YUKON ENERGY CORPORATION

2021 GENERAL RATE APPLICATION
ROUND 1 INTERROGATORY REVISED RESPONSES FILED

August 24, 2021

Figure 3: Midgard Parametric CAPEX Model

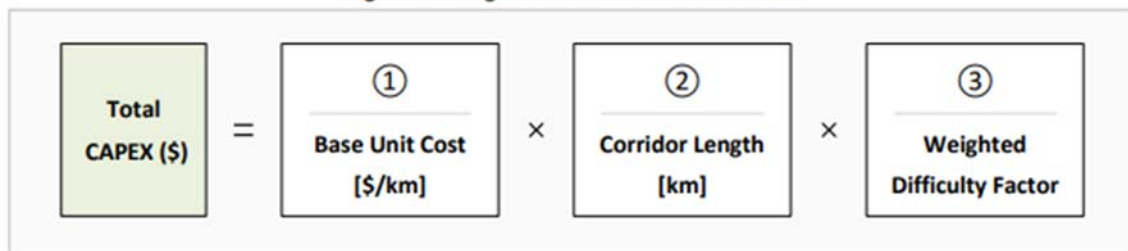
While YEC provided the total cost for the Southern Lakes Transmission Line project, it did not provide a cost breakdown. Thus, the Board directs YEC to provide a cost breakdown of this project.

As discussed in Section 3 of the report referenced in the original response, a cost breakdown was not used to create the \$166 million cost estimate. Rather, a factor-based Capex model was used to develop the Class 5 cost estimate for the project based on the corridor length and anticipated route difficulty. Figure 3 from the report is provided as reference below.

The table below provides a high-level estimate of the how this overall capital cost may break down based on typical transmission projects; however, this is subject to change following project initiation and planning.
